Core Bus Corridor 12: Rathfarnham - Preliminary Submission

1.0 Introduction

A demonstration of how the proposed junction design does not enable cycling for people of all ages and all abilities

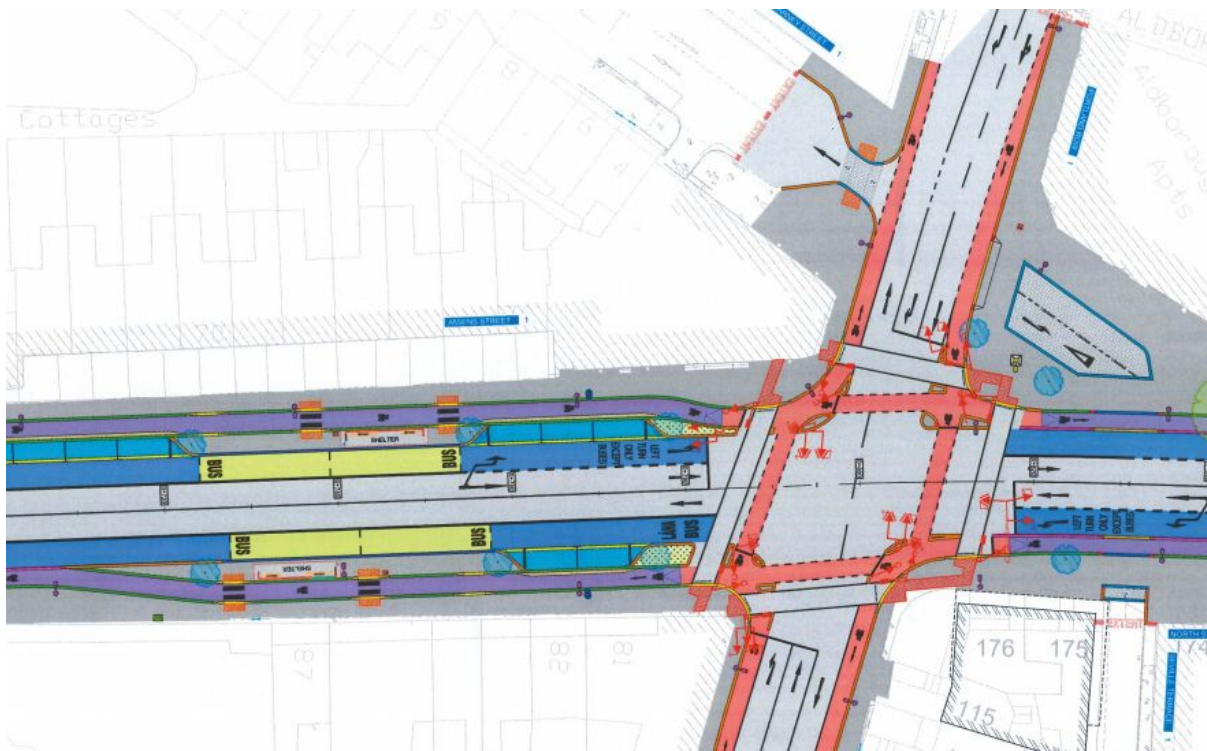
Many of the proposed junctions on this Core Bus Corridor do not meet the criteria in the NTA's National Cycle Manual. There is use of streaming lanes (an orphaned cycle lane between two traffic lanes) at junctions along this route.

- *Streaming cycle lanes can only be used in low traffic speed environments where there is minimal speed differential between cyclists and adjacent traffic*
- *Streaming is not suitable along HGV routes*
- *Streaming cycle lanes should only be used beside right or left hand pockets (i.e. distinct lanes dedicated to turning movements) and should not exceed 30.0m in length*

In essence the use of streaming cycle lanes at junctions goes against the manual advice. These concept junction designs are also not suitable for all ages and abilities.

Greater segregation for cyclists is needed at major junctions along the route in order to enable and encourage more people to cycle. Segregated cycle tracks alongside roads

provide segregation through space. 'At junction' segregation should be provided through specific allocated crossing time instead. Cyclists should be provided with their own set of traffic lights and their own phase, sometimes combined with the pedestrian phase on parallel crossings. This means that cyclists are never moving at the same time as traffic that would cross their path.
